Written submission for Deadline 4, 13/01/2021

Richard Reeves, AP EA1N AFP 133 / IP 2002765

Responses, Questions, Corrections

RE The Applicants' Landfall Hydrogeological Risk Assessment 24/02/2021

NB East Anglia chalk aquifer indicated in pink shading above

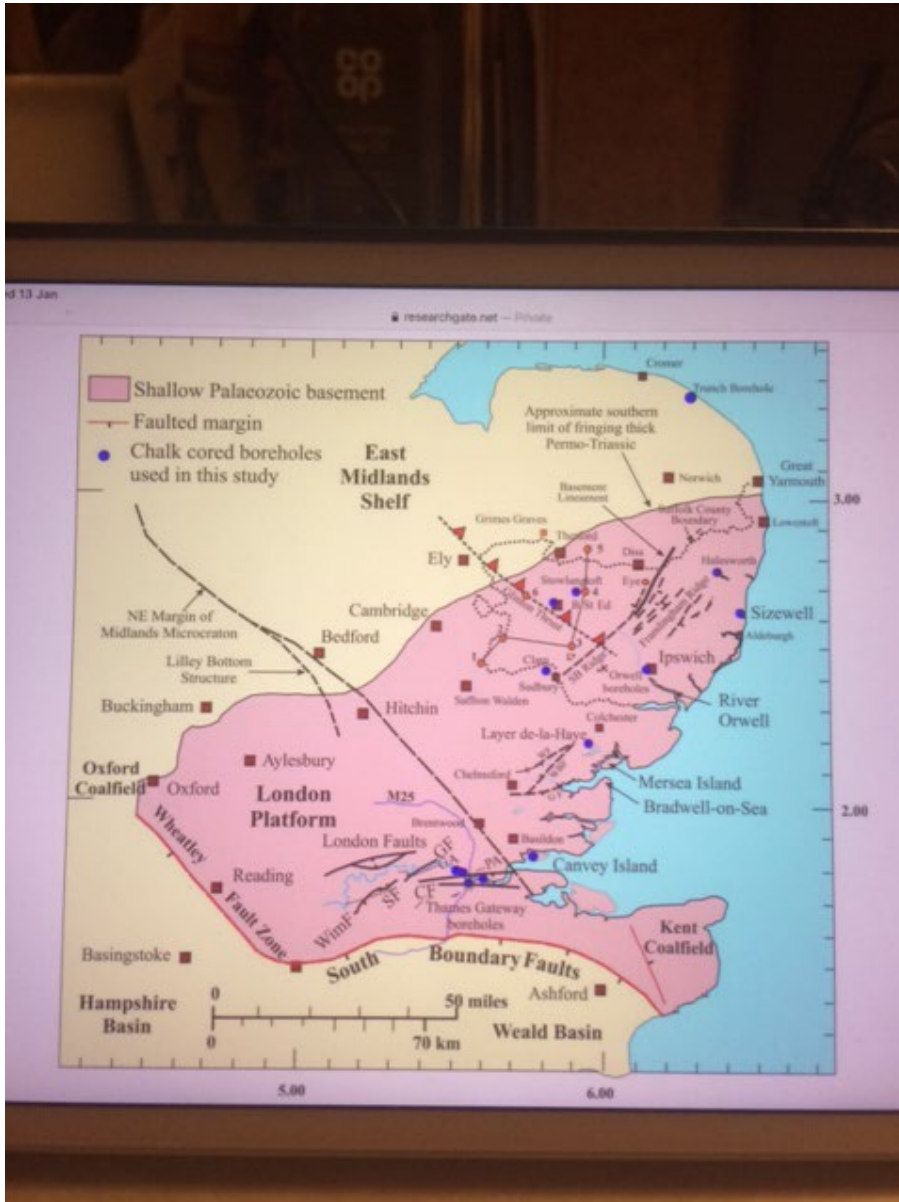
As the map below, and associated cited articles of research clearly illustrate, nothing could be further from the truth. The aquifer underlies not merely the county of Suffolk, but the East Anglian region as a whole. Furthermore, the region-wide aquifer, occupying the entire upper chalk stratum at a depth of approximately 10m below ground level at Wardens Centre / Ness House, where I have personal access to, and knowledge of, the private pumping station, extends, on its gentle south easterly subterranean slope, under the bed of the north sea itself, along the whole of the east Anglian coastline.

It is clear, from these facts, that any process of HDD, either onshore or offshore; trenching; onshore boreholes; associated waste, pollution, industrial contamination; erosion of onshore ground conditions or offshore sea-bed destruction, will severely, if not catastrophically, damage and compromise this unique and vital natural resource.
